V2_Drainage Report - Final_COMMENTS.pdf Markup Summary

Ascent Church

Final Drainage Report

PCD File No: PPR265

DETENTION BASIN OUTLET STRUCTURE DESIGN

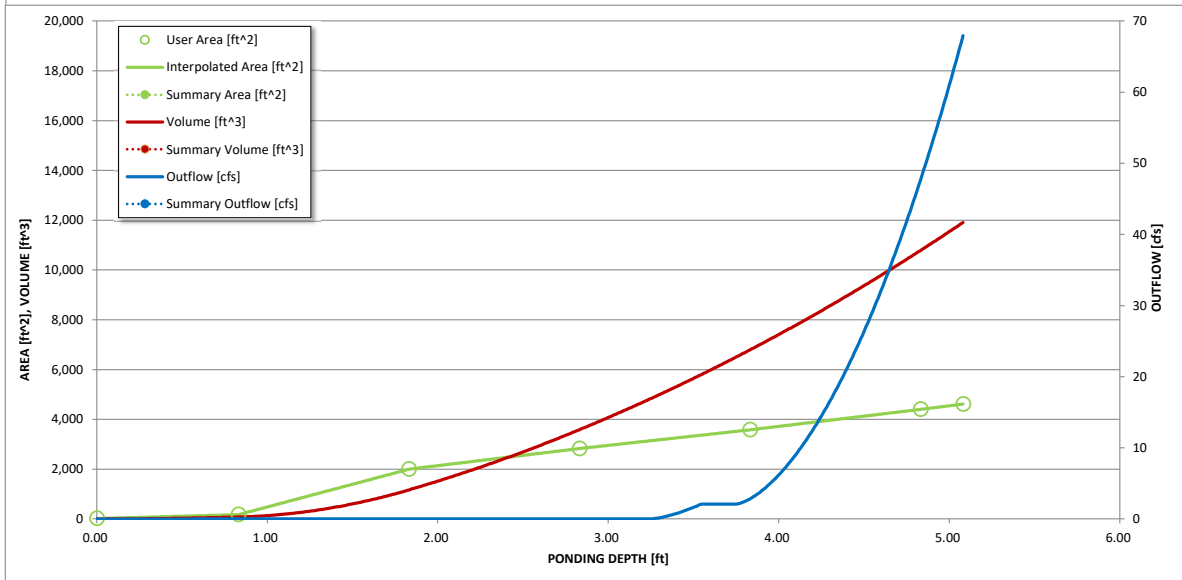
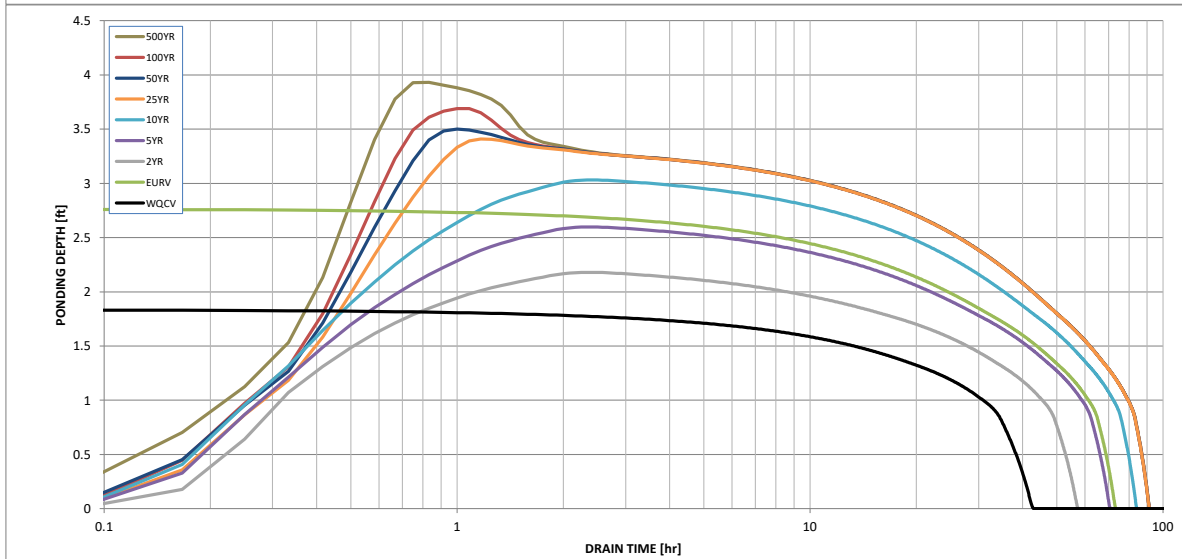
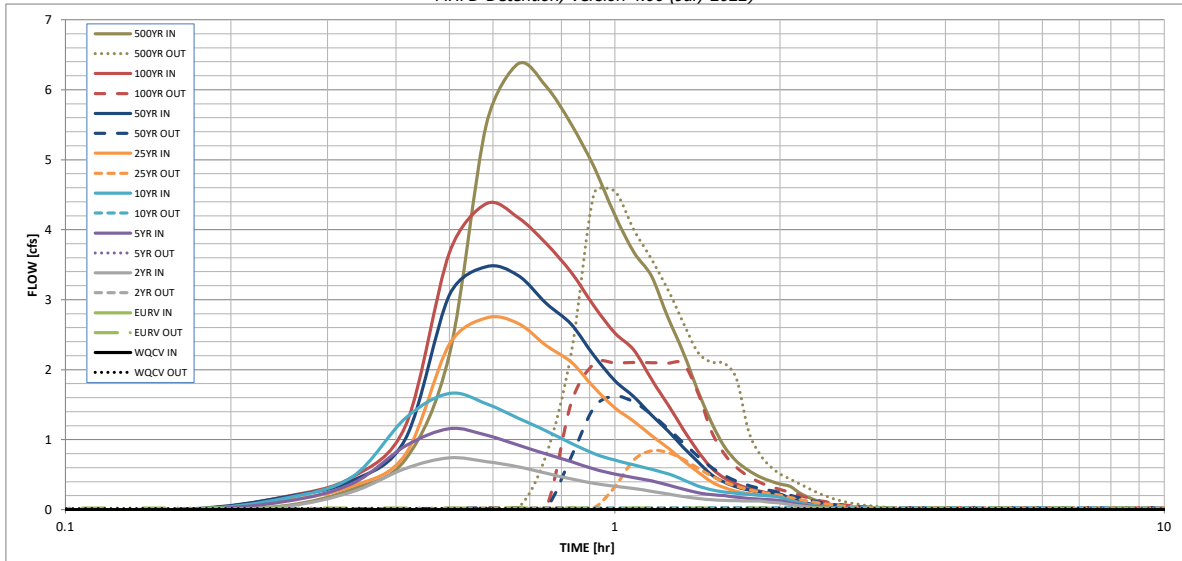
Since this orifice is on the orifice plate please input the centroid/area in the section above. This section is for orifices cut into the concrete structure above the plate.

CDs show 3x3' grate

ASCENT CHURCH PROPOSED DRAINAGE MAP

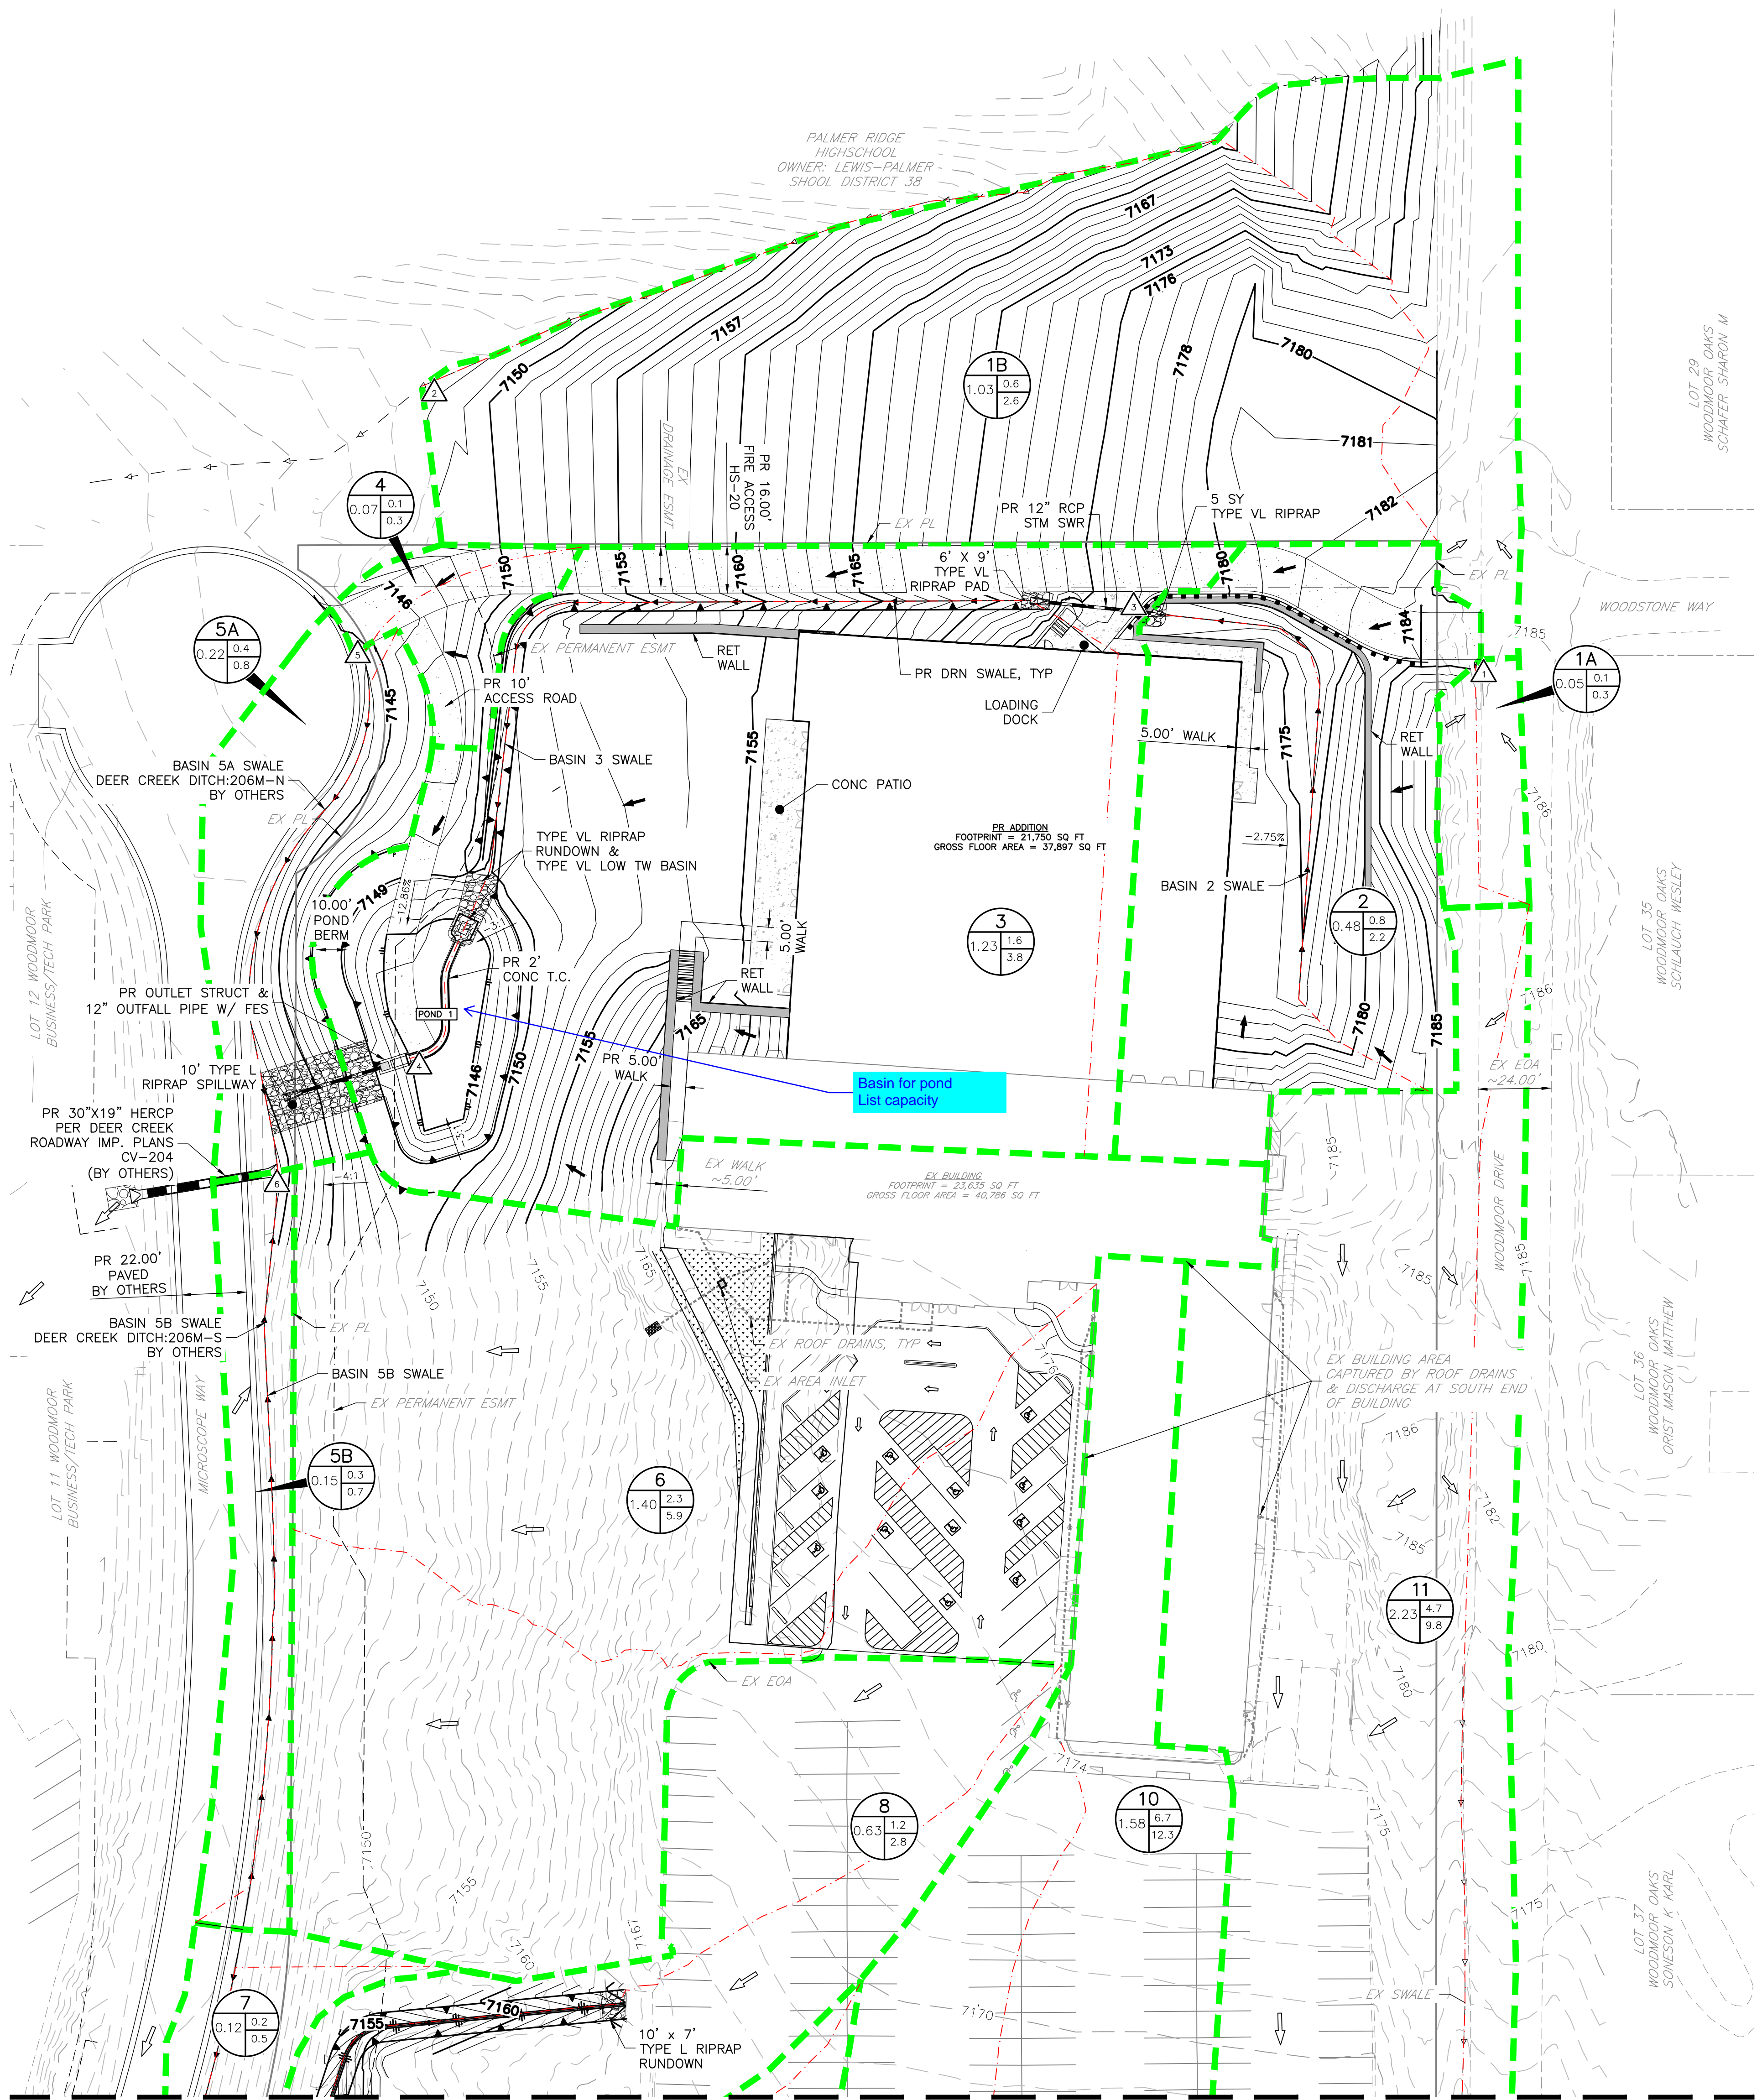
Basin for pond
List capacity

ASCENT CHURCH PCM APPLICABILITY MAP

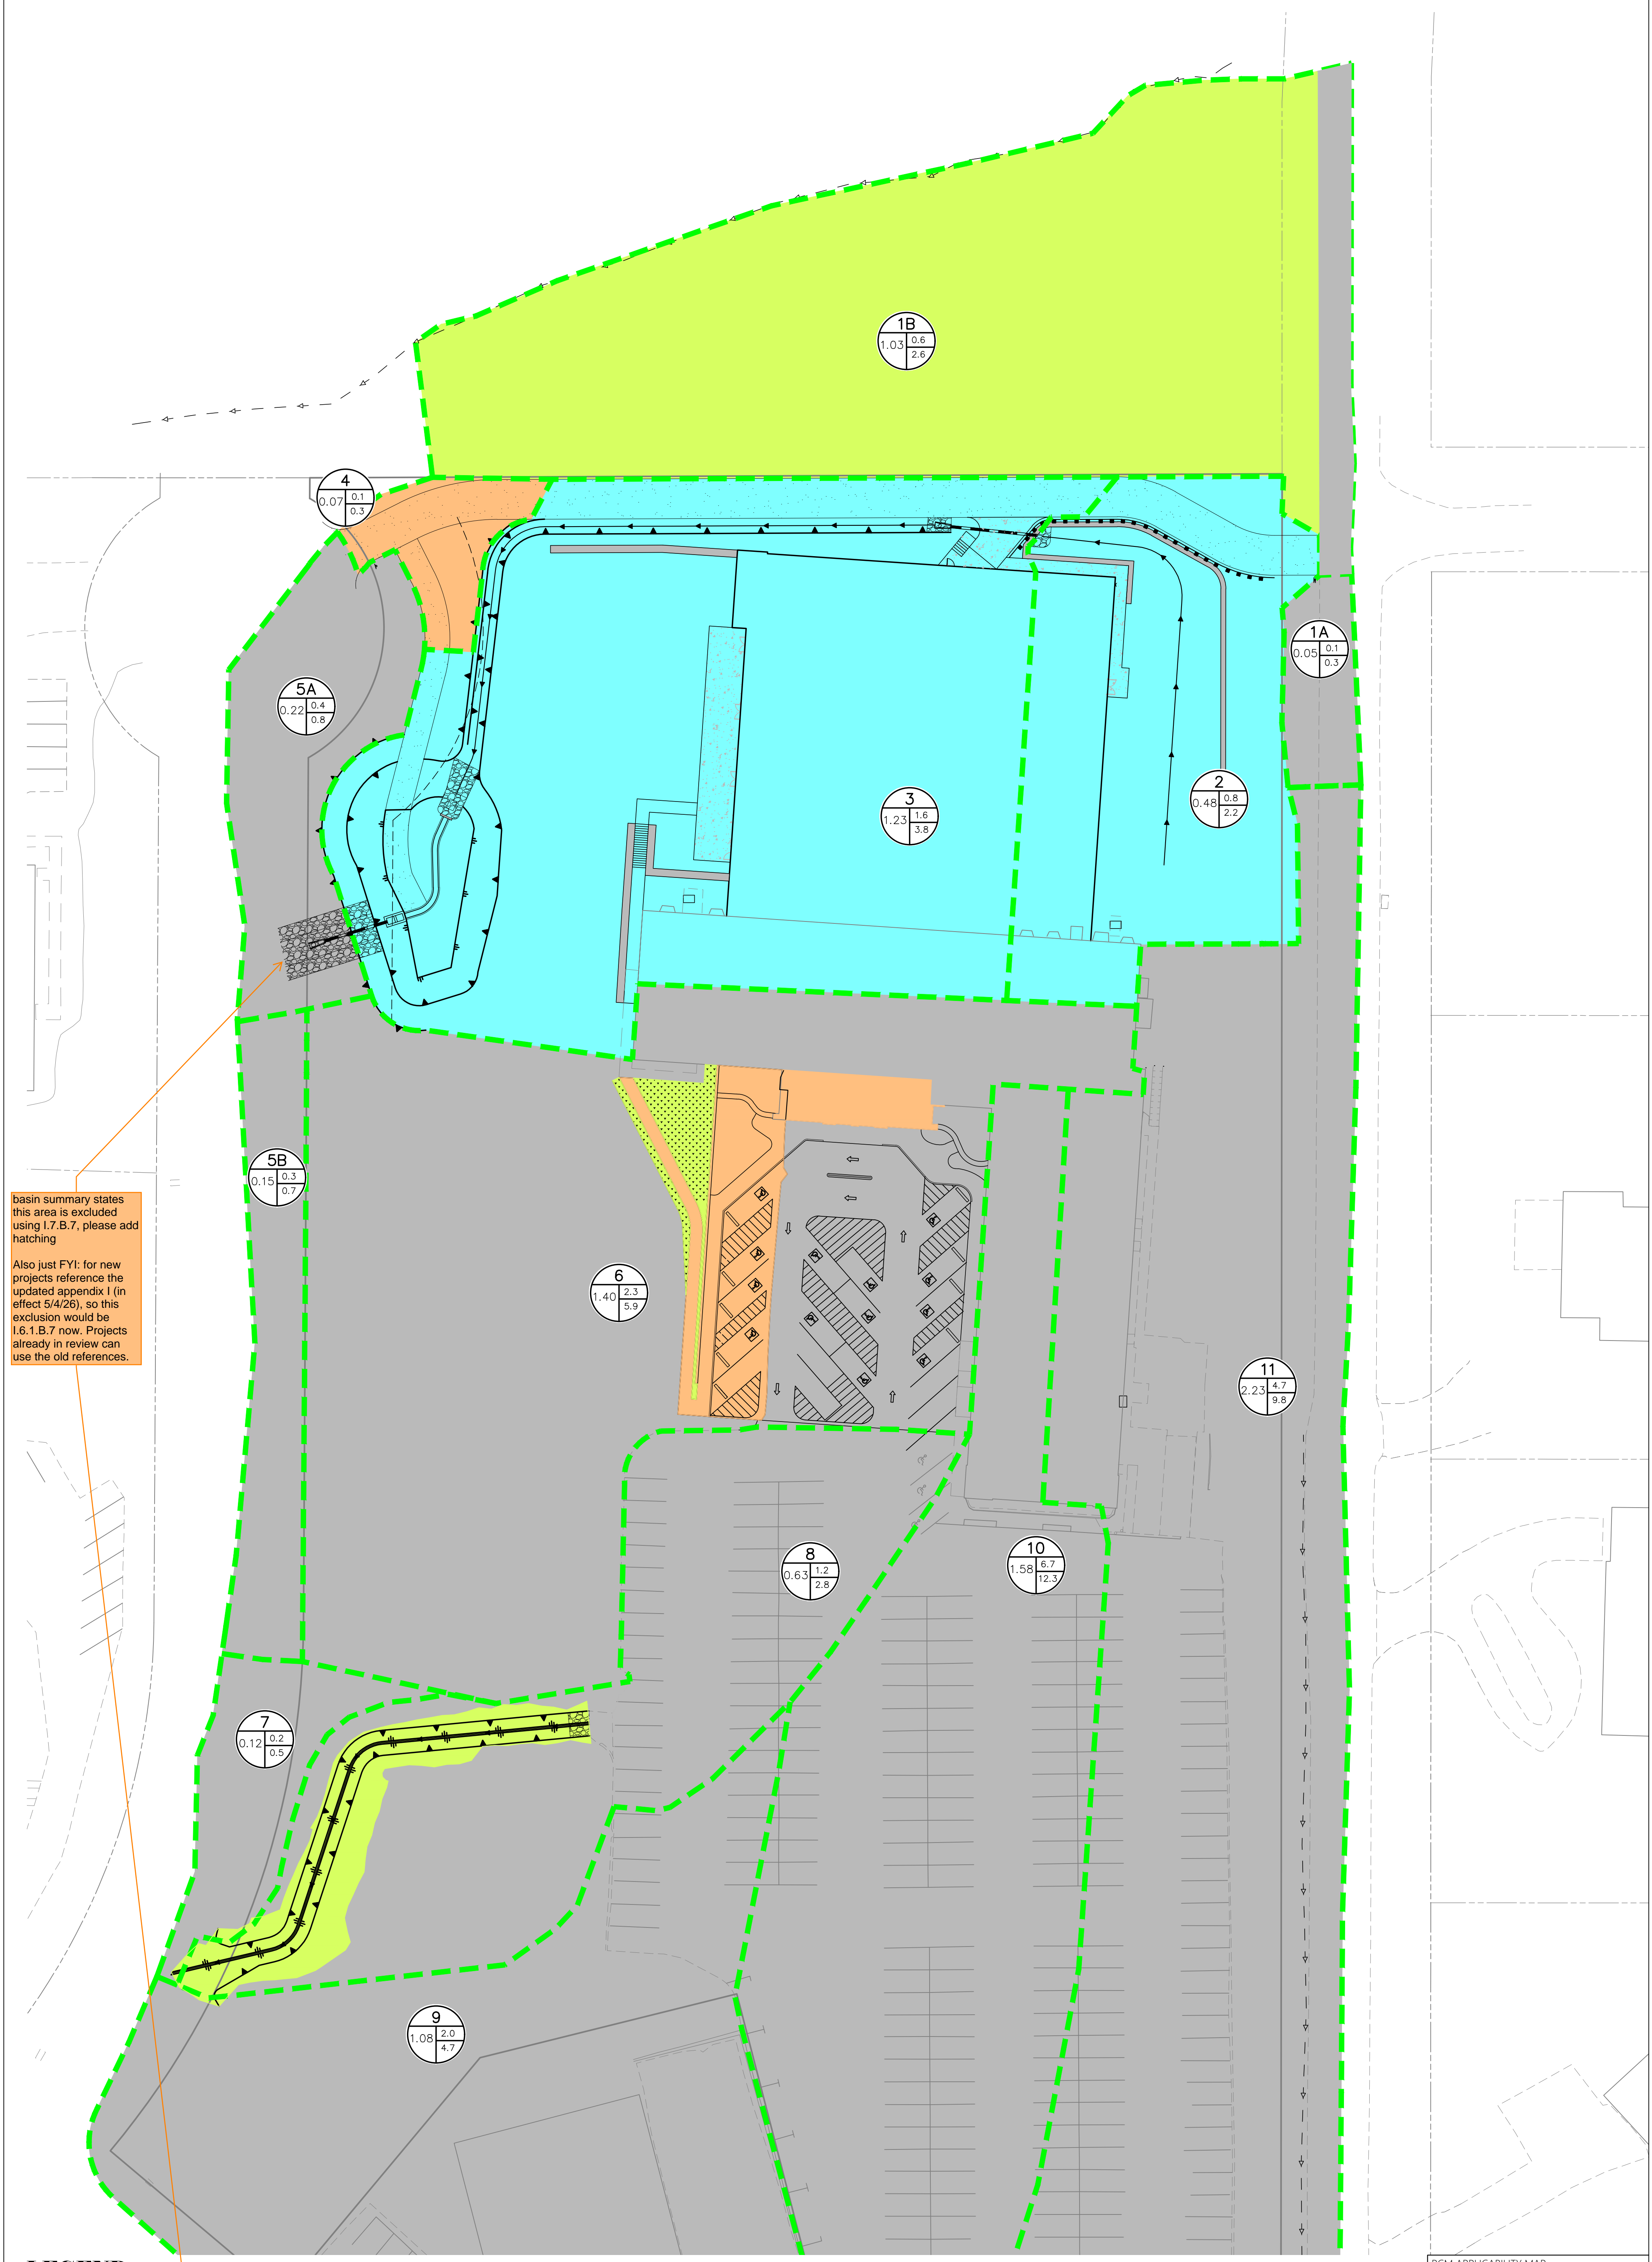
Also just FYI: for new projects reference the updated appendix I (in effect 5/4/26), so this exclusion would be I.6.1.B.7 now. Projects already in review can use the old references.

basin summary states this area is excluded using I.7.B.7, please add hatching
